COA 16-63

732 Delaware Avenue

Installation of a new 6' high chain link fence and three 4' high gates, coupled with a variance request to deviate from Code Sec. 22-59 (g)(8)b, which requires gates and fences to be wood, an appropriate composition of iron, metal or aluminum, or masonry piers with wood pickets, whereas the proposed fence is chain link in green color.

HISTORIC PRESERVATION BOARD : PUBLIC HEARING

Proposed fences and gates

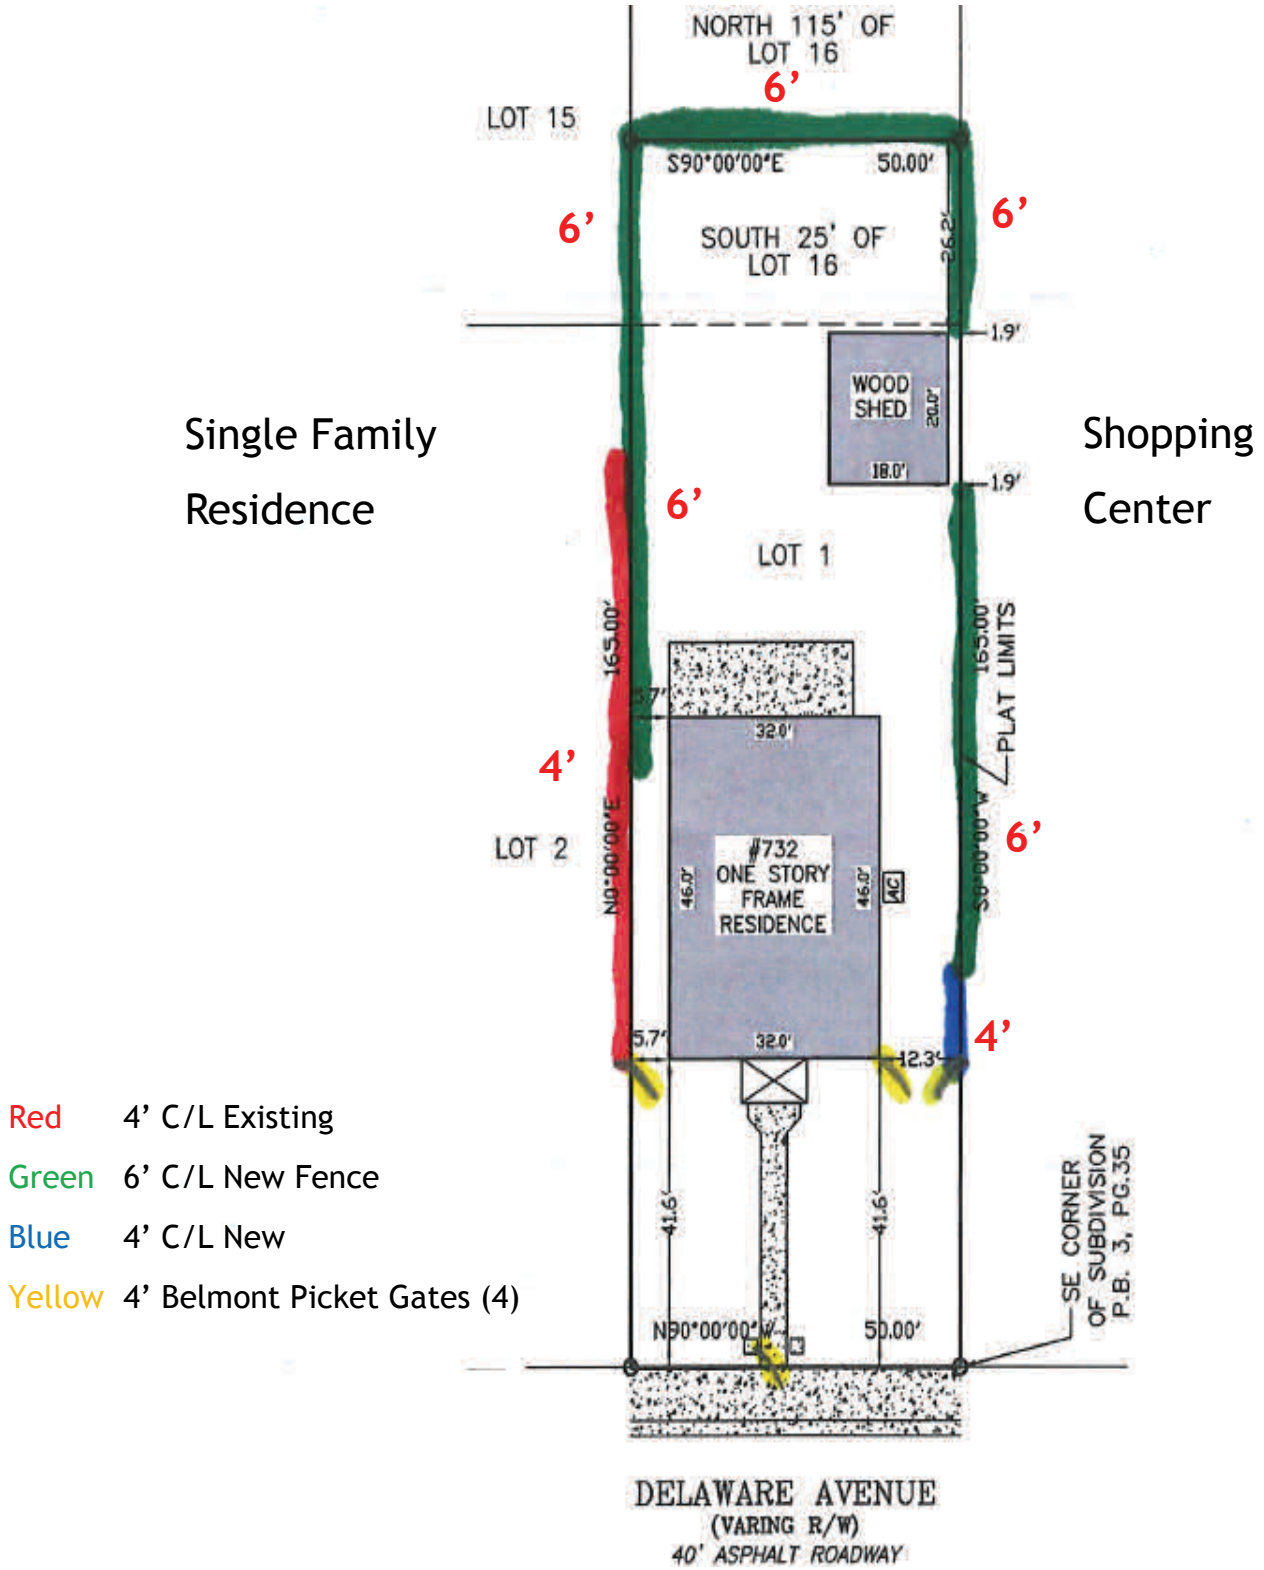
The square columns flanking the sidewalk entrance to the structure are new additions which were added at the time of rehabilitation. The owner is requesting approval to add three picket aluminum “Belmont” gates to the existing front columns and to be placed on both sides of the house. Those gates will provide positive visual finish and add a measure of security to the front yard.

The gates addition will have a positive impact on the visual appearance of the property and overall historic district. Adding a gates to the front of a property is not appropriate in every instance, but due to the commercial nature of this street, a gates creates a sense of appropriate enclosure.

The current proposal also seeks to install 4 and 6 foot high chain link fence on the sides and rear perimeters that is non-compatible with the materials and architectural features appropriate to protect the historic integrity of the property and its environment. Staff would rather see a continuation of the Belmont or wooden picket fence along the property lines where the fence is proposed, with enhancement to existing landscape screening if needed.

In conclusion, based upon Secretary of Interior Standards 2 and 9, staff recommends that the Board approve the request for installation of the three Belmont gates, deny variance request to deviate from Code Sec. 22-59 (g)(8)b and approve the proposed fence with condition that the chain link fence be replaced by a more architecturally compatible style of fence such as Belmont or wood picket fence 4 or 6 foot high as shown in the proposal.
